Change Order

Radcliff Elementary School Renovation
- Phase 3
1145 S. Dixie Boulevard
Radcliff, Kentucky 40160

CHANGE ORDER NUMBER: 012**DATE:** October 20, 2011**OWNER:** ☒**ARCHITECT:** ☒**CONTRACTOR:** ☒**FIELD:** ☐**TO CONTRACTOR (Name and address):**

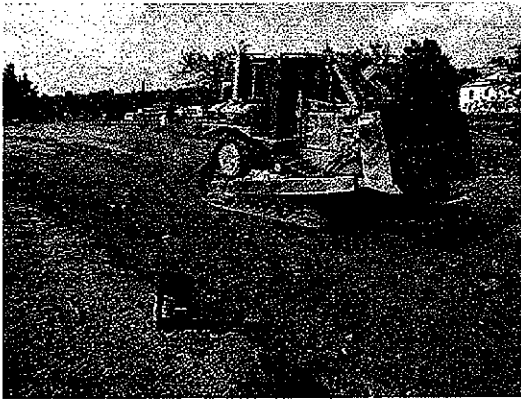
Description of Observations/ Testing performed today: AEI representative arrived onsite @ 7:42 a.m. to perform inspection for soils around the east and south sides of the elementary school building. Work was already being performed of rolling in the areas with the smooth drum roller to compact the areas prior to arrival. There were four areas identified as unsuitable and needed to be undercut. Area one was approximately 89 cubic yards, area two was approximately 70 cubic yards and area three was approximately 89 cubic yards. After these three areas were undercut from depths varying from 2 feet to 3 feet approximately they were covered with a layer of filter fabric and then backfilled with concrete waste as previously used on the site before. Area four is approximately 360 cubic yards assuming a 2 foot depth of undercut but was not performed on this day. See photo documentation below.

Area 1 Filled in.

Area 2 Filled in.

Area 3 Being Filled in.

Example of failed proof roll.

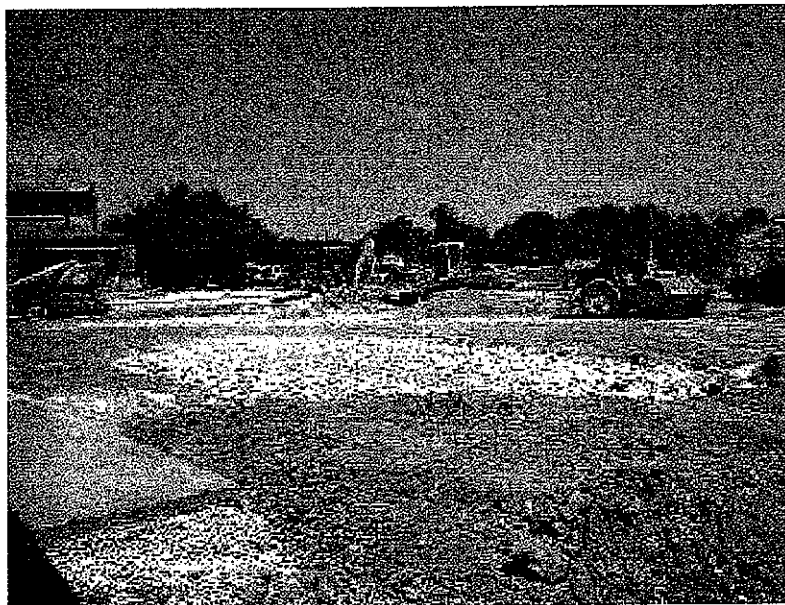
Description of Observations/ Testing performed today: AEI representative arrived onsite @ 7:45 a.m. to perform inspection for soils around the east side of the elementary school building. As AEI arrived on site the area was being scraped off with a dozer and was afterwards rolled in with a smooth drum roller and then proof rolled with a fully loaded dump truck. The initial failing areas measured approximately 34'x16', 23'x11' and 25'x24'. The proof rolling was also observed by Rusty Taylor of the Hardin County School System. Final undercut dimensions were taken with the assistance of Rusty Taylor and were as follows: 22'x38'x1.5', 9'x22'x2', 9'x28'x1.5' and 12'x23'x1.5' for a total of 2,442 cubic feet or 90.44 cubic yards. Crushed aggregate was placed over top of a geotextile fabric liner and then pushed in with a dozer and compacted with a smooth drum roller. AEI was also notified after aggregate placement that DGA would be used over top of this whole east side area to help protect the soil in the event of rain chances in the coming days. See photo documentation below.

Undercut areas being filled in with crushed aggregate.

PROJECT No. 211-059

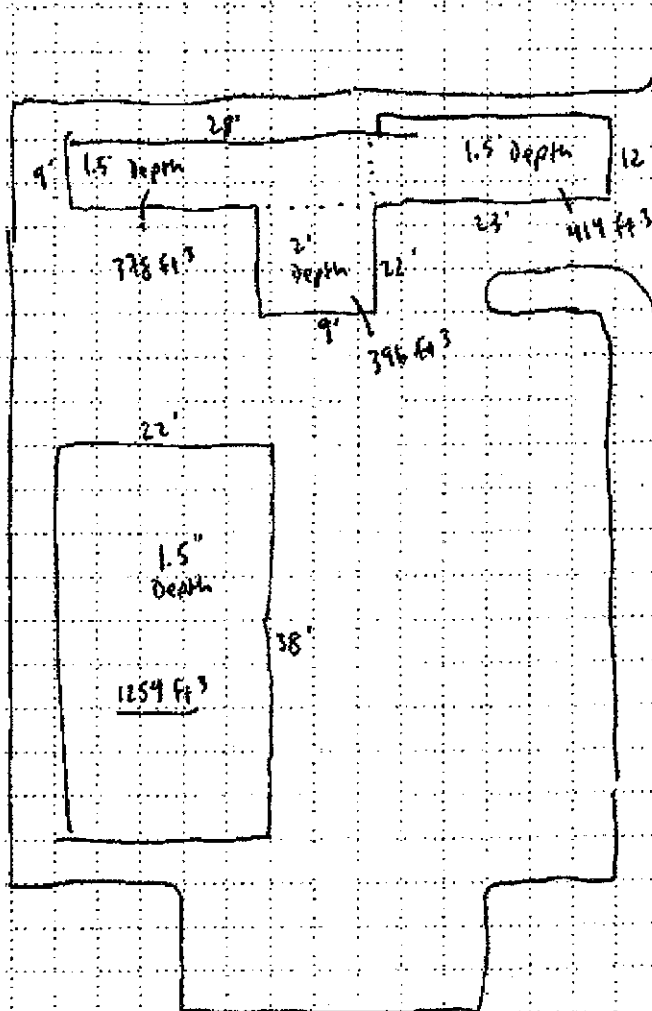
414
396
378
+ 1254

$2442 \text{ ft}^3 \div 27 =$

90,444 yds³
